UNITED STATES PATENT AND TRADEMARK OFFICE

APPLICATION NO.	FILING DATE	FIRST NAMED INVENTOR	ATTORNEY DOCKET NO.	CONFIRMATION NO.
09/835,711	04/16/2001	Kia Silverbrook	360040-21	7729

Office Action Summary

DETAILED ACTION

U.S. Patent Feb. 6, 1990 Sheet 1 of 3 4,899,174

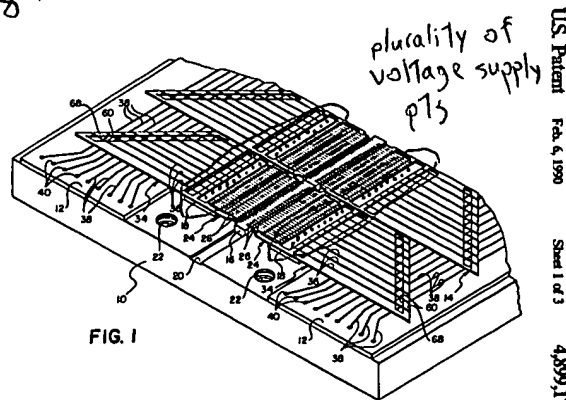
Newman discloses, with respect to claim 130,

- a power distribution arrangement (See figure, reference 38; column 4, lines 1-11)
- for an elongate printhead (See figure 1, references 16, 18; column 1, lines 1-22)
- of a kind having a plurality of longitudinally spaced voltage supply points (See figure 1, drawn-in reference)

printhead represented
by "16" and "18"

- interconnect means connecting the voltage supply points to power (See figure 1, reference 36, 38; column 4, lines 1-11)

Newman discloses, with respect to claim 134, that the interconnect means also includes a plurality of control lines for connection to selected others of the voltage supply points on the printhead (See figure 1, references 36, 38; column 4, lines 1-11).

Newman discloses, with respect to claim 135, that the interconnect means is in the form of one or more circuit boards, with **TAB** connecting printed circuit boards to the printhead (See figure 1, reference 12; column 1, lines 15-22; column 3, lines 39-43).
